Docket No. 50-312

SUBJECT: NUREG-0737 ITEM II.K.3.30, SMALL BREAK LOCA METHODS

Rancho Seco Nuclear Generating
Station

SAFETY EVALUATION REPORT
FOR THE
BABCOCK AND WILCOX OWNERS GROUP
SMALL BREAK LOSS-OF-COOLANT ACCIDENT
EVALUATION MODEL, CRAFT2 (REV. 3)
(BAW-10092P, REV. 3 AND BAW-10154)

Figure 2. Comparison of CRAFT2 to RELAP5.
RELAP5/MOD2 sensitivity study on percentage
of steam generator tubes wetted by AFW.

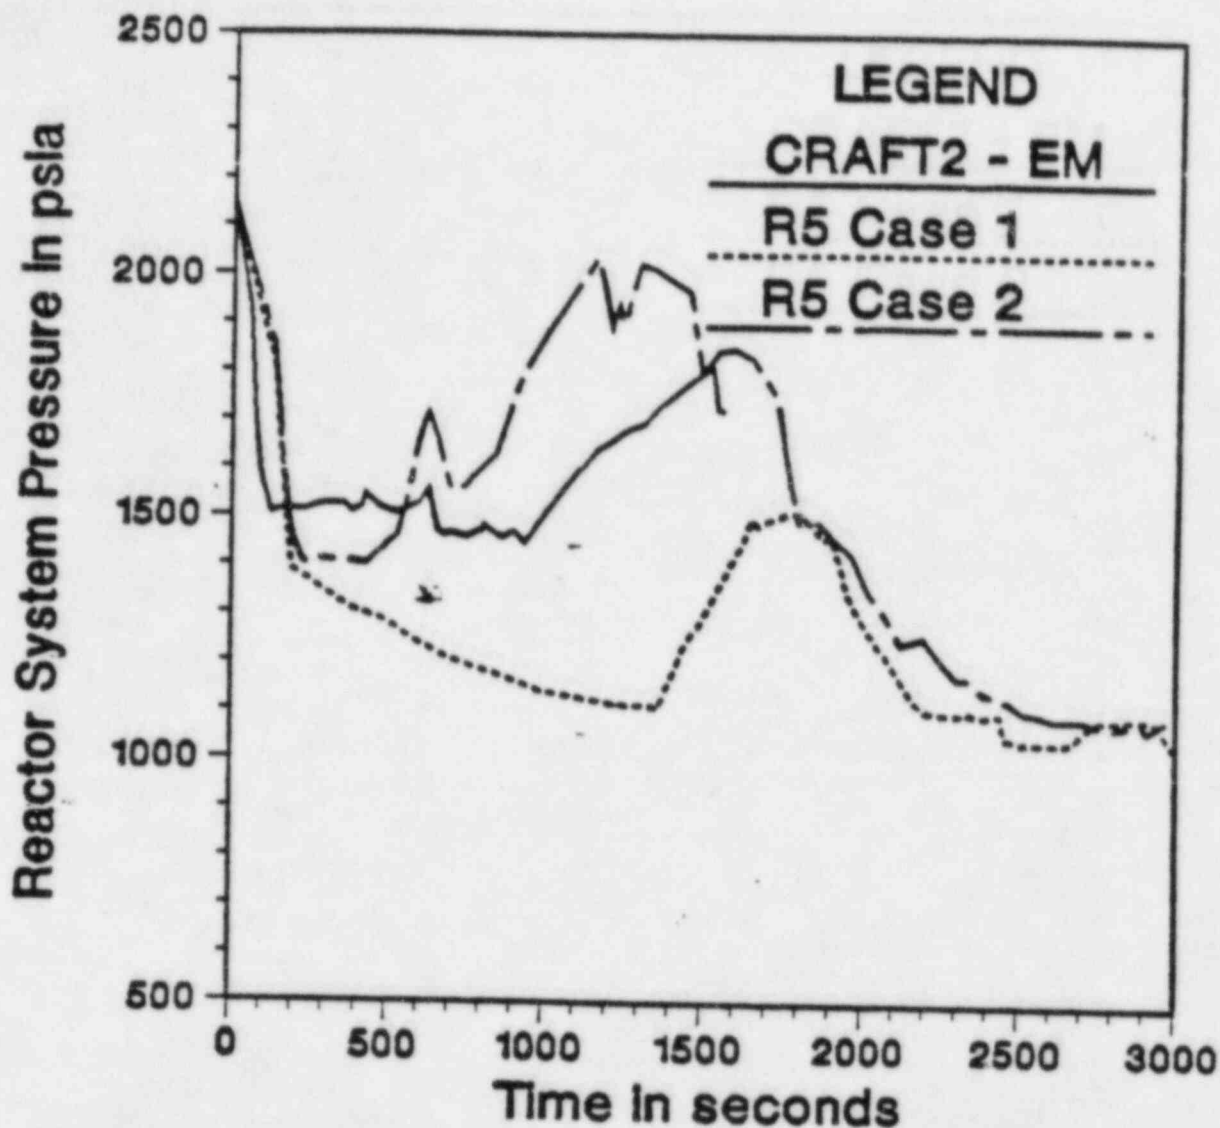
Recently completed analyses performed by the NRC with the RELAP5/MOD2 computer program have been qualitatively compared to the B&W CRAFT2 results for a 0.01 square foot cold-leg break (Reference 15). While this study was not intended to be a direct audit analysis, input assumptions were selected to explore the effects of natural circulation, reactor system repressurization, and boiler-condenser heat transfer including the effectiveness of Auxiliary Feedwater (AFW) spray on the upper OTSG tube elevations.

The RELAP5/MOD2 analyses indicated that although AFW wetting effectiveness can influence the primary system response, the general trends are unaffected. The analyses demonstrate that repressurization can occur during a small break LOCA at a B&W lowered-loop plant. Figure 2 provides a comparison of the RELAP5 results to a similar CRAFT2 analysis. This confirms the B&W CRAFT2 results for a similar size break. The timing of the operator action to raise the secondary system water level to 95% was found not to be critical. Some boiler-condenser heat transfer was found to occur with the level at 50% of the operating range, which terminated the increase in the reactor system pressure before the level was raised to 95%. Finally none of the conditions examined led to core uncover or heat-up.
